V2500-A1/A5 SERIES NACELLE SERVICE BULLETIN

V2500-NAC-78-0213

NACELLE – EXHAUST – THRUST REVERSER – SLEEVE – ADDITION OF IDENTIFICATION PLATE

Thrust Reverser Identification Plate Installation
Figure 1

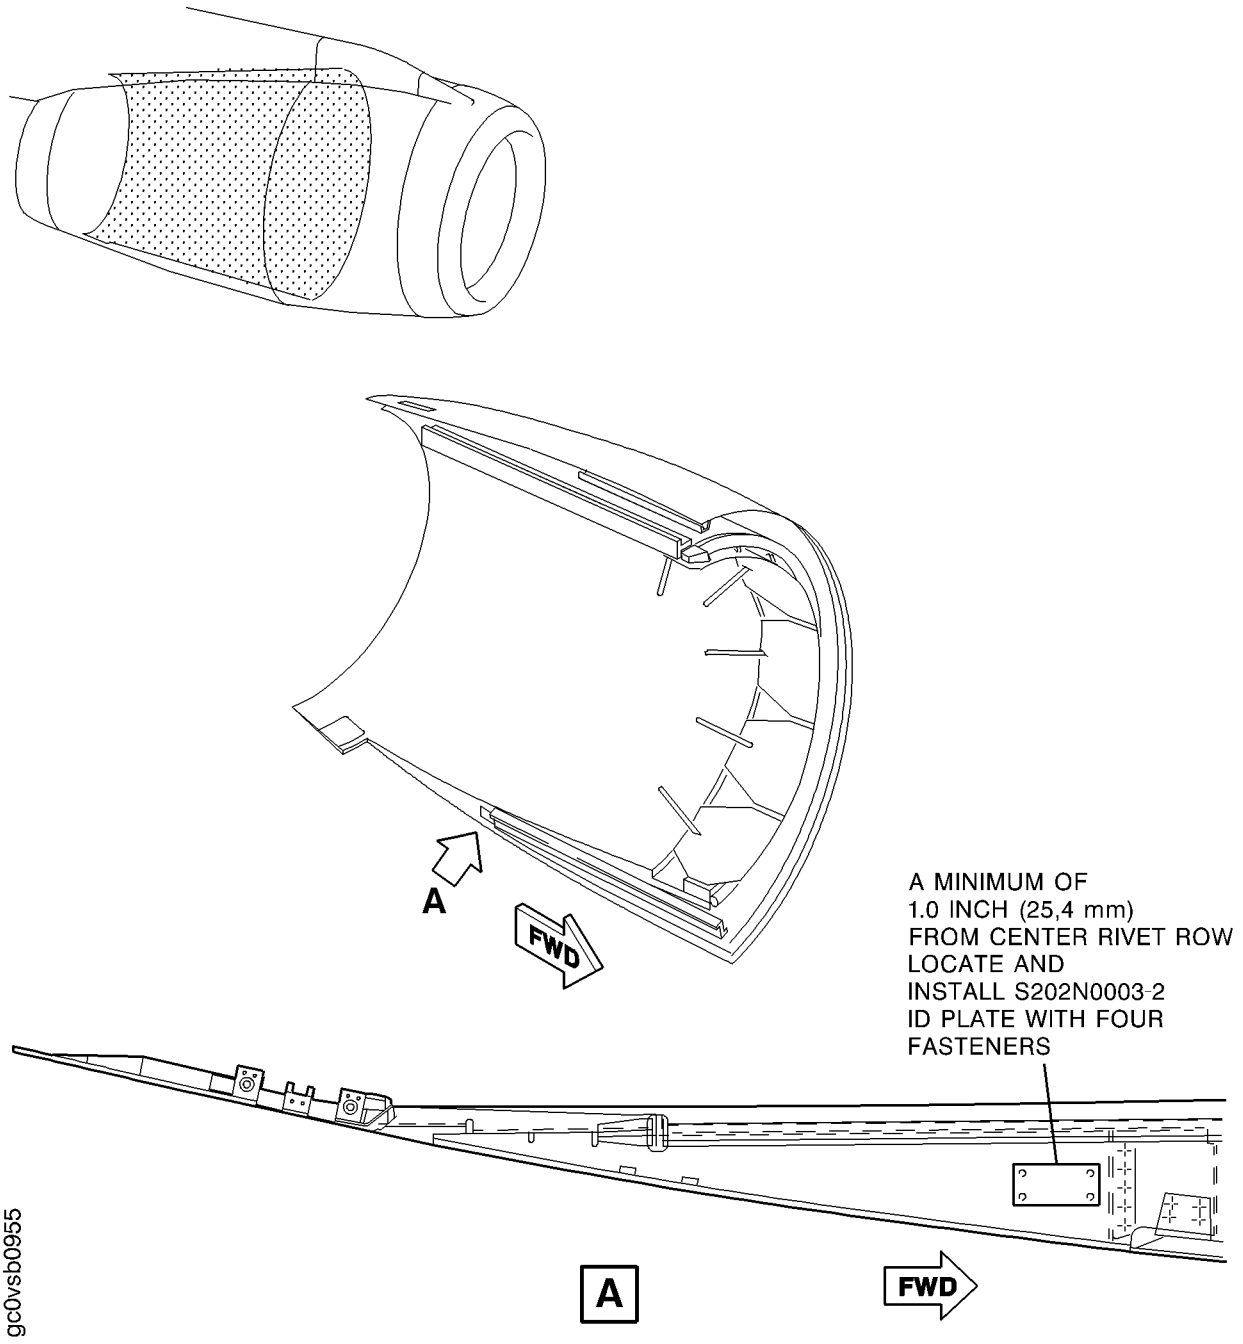
- A. Option 1: Modify the aluminum thrust reverser translating sleeve by installing the identification plate as shown in Figure 1.

- (1) Prepare the area to receive the identification plate. Use CoMat 01-438 solvent and a clean, lint-free cloth (CoMat 02-099) to remove all contamination. Refer to Figure 1.
- (2) Use the S202N0003-2 identification plate as a hole template to locate and make four marks on the sleeve where the four fasteners will be installed. Locate the edge of identification plate a minimum of 1.0 inch (25.4mm) from the center of the adjacent row of rivets as shown in Figure 1.
- (3) Mark the identification plate with the appropriate part number as previously ink-stamped on the translating sleeve. Use vibroetch or electroetch method. Refer to the IAE V2500 Standard Practices/Processes Manual, Chapter 70-09-00-400-001.

- (4) Drill four 0.098 – 0.106 inch (2,49 – 2,69mm) diameter holes. Remove burrs from the holes. Apply conversion coating (CoMat 07-028) to any bare aluminum surfaces.

- (5) Mix the catalyst (CoMat 07-139), primer (CoMat 07-140) and thinner (CoMat 07-144). Refer to the manufacturer's instructions.
- (6) Wet install the four CR2663-3-2 rivets into each corner of the identification plate. Make sure the identification plate is face-side up and secure.
- (7) Return the modified thrust reverser translating sleeve to a serviceable condition.

- B. Option 2: Modify the composite thrust reverser translating sleeve by installing the identification plate as shown in Figure 1.

- (1) Prepare the area to receive the identification plate. Use CoMat 01-438 solvent and a clean, lint-free cloth (CoMat 02-099) to remove all contamination. Refer to Figure 1.
- (2) Use the S202N0003-2 identification plate as a hole template to locate and make four marks on the sleeve where the four fasteners will be installed. Locate the edge of identification plate a minimum of 1.0 inch (25.4mm) from the center of the adjacent row of rivets as shown in Figure 1.
- (3) With a drill bit for composites, drill four 0.098 – 0.106 inch (2,49 – 2,69mm) diameter holes.

- (4) Mark the identification plate with the appropriate part number as previously ink-stamped on the translating sleeve. Use vibroetch or electroetch method. Refer to the IAE V2500 Standard Practices/Processes Manual, Chapter 70-09-00-400-001.
- (5) Install the four CR2663-3-2 rivets into each corner of the identification plate. Make sure the identification plate is face-side up and secure.
- (6) Return the modified thrust reverser translating sleeve to a serviceable condition.
